# Access Compliance Report

## Public Rights-of-Way

### (Curb Ramps)

Intersection ID: 43592	Main Street: DAVID_TAYLOR_DR	Cross Street: ANDREW_CARNEGIE_BV	Location: SE
ADA ID: A68C1E40BF31	Ramp Type: Para	Initial Pass/Fail: Fail	Overall Compliance: No
		Severity Score: 25

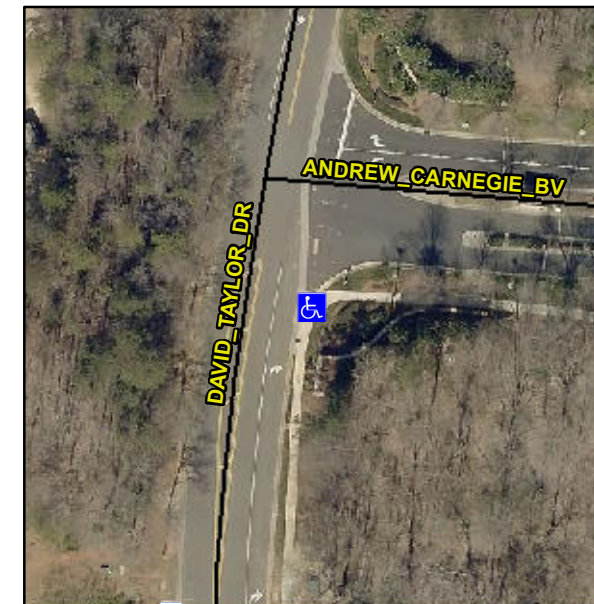
**RT RP < 5%**

**R304.3.2**

Compliance	Description	Data	Compliance	Description	Data
N/A	Ramp Length LT (in)	50.5	N/A	Ramp Length RT (in)	46.5
Yes	Ramp Width LT (in)	75.0	Yes	Ramp Width RT (in)	71.0
No	Ramp Slope LT (%)	18.5	Yes	Ramp Slope RT (%)	3.1
Yes	Ramp XSlope LT (%)	1.4	Yes	Ramp XSlope RT (%)	0.6
N/A	Landing Length (in)	N/A	N/A	DWS Provided?	N/A
N/A	Landing Width (in)	N/A	N/A	DWS Contrast?	N/A
N/A	Landing Slope (%)	N/A	N/A	DWS Length (in)	N/A
N/A	Landing X Slope (%)	N/A	N/A	DWS Full Width?	N/A
N/A	Landing Curb? (Y/N)	N/A	N/A	DWS Offset (in)	N/A
N/A	Shared Landing?	N/A			
N/A	Gutter Ponding?	N/A	N/A	Gutter Slope (%)	N/A
N/A	Gutter Lip Ht (in)	N/A	N/A	Gutter X Slope (%)	N/A
N/A	Painted X Walk1?	No	N/A	Painted X Walk2?	N/A
	X Walk 1 Direction	To N		X Walk 2 Direction	N/A
N/A	X Walk 1 Width (in)	N/A	N/A	X Walk 2 Width (in)	N/A
	X Walk 1 Slope (%)	3.4		X Walk 2 Slope (%)	N/A
	X Walk 1 X Slope (%)	6.4		X Walk 2 X Slope (%)	N/A
N/A	Ramp inside XWalk1?	N/A	N/A	Ramp inside XWalk2?	N/A

**Remove & Replace Entire Ramp.**
